ROCHESTER GAS AND ELECTRIC CORPORATION • 89 EAST AVENUE, ROCHESTER, N.Y. 14647

August 5, 1976

This letter is in response to your letter of June 24, 1976, which requested additional information regarding our proposed spent fuel pool modification. Enclosed please find the responses to your questions and the responses to the Staff's questions resulting from the May 21, 1976 meeting between the NRC Staff and RG&E.

Figure 15-1

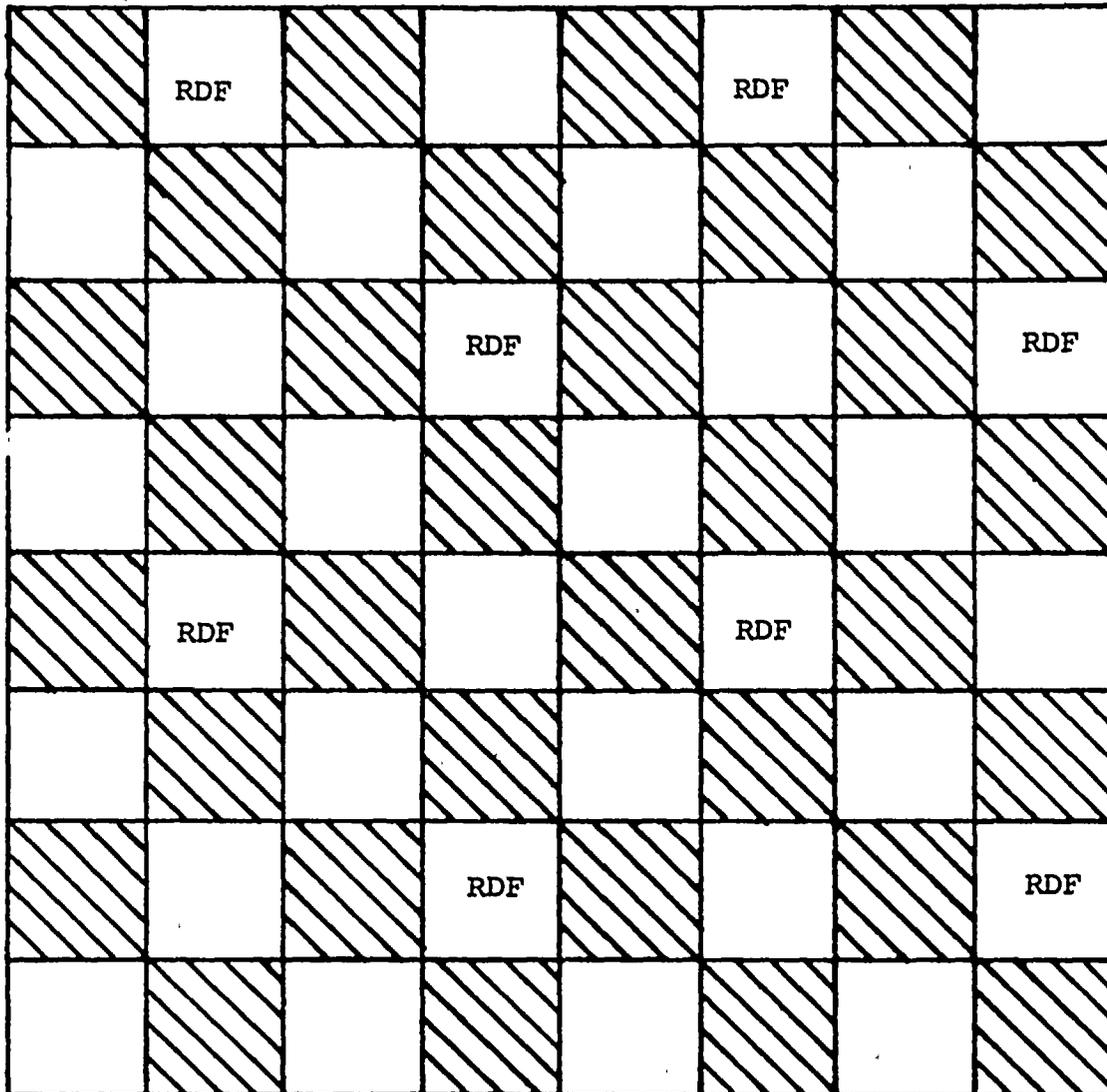
- (a) What consideration has been given to reducing the probability or consequences of a tornado missile impacting on stored spent fuel?

RESPONSE: The consequences of a postulated missile impacting stored spent fuel in the proposed racks (595 locations) has been decreased below that of the existing racks (210 locations) by preventing the fuel assemblies in the latest discharge batch from being all grouped together.

The fission product density is greatest in fuel assemblies that have the shortest cooldown time, assuming similar irradiation. Therefore, the stored fission product density can be reduced by surrounding a recently discharge fuel assembly with fuel assemblies that have been stored for a year or more. Figure 15-1 illustrates a section of the proposed spent fuel storage racks with the recent discharge stored as illustrated. The remaining storage locations were assumed to be filled with fuel assemblies that have been out of the reactor for one year (See Figure 15-2).

The above quantity was calculated for the existing spent fuel racks and the proposed spent fuel racks with the loading pattern illustrated on Figure 15-2. Since this quantity is less for the proposed rack and loading pattern than for the existing racks, the consequences of a missile which transverses the same spent fuel pool volume will also be less than for the existing pool structure.
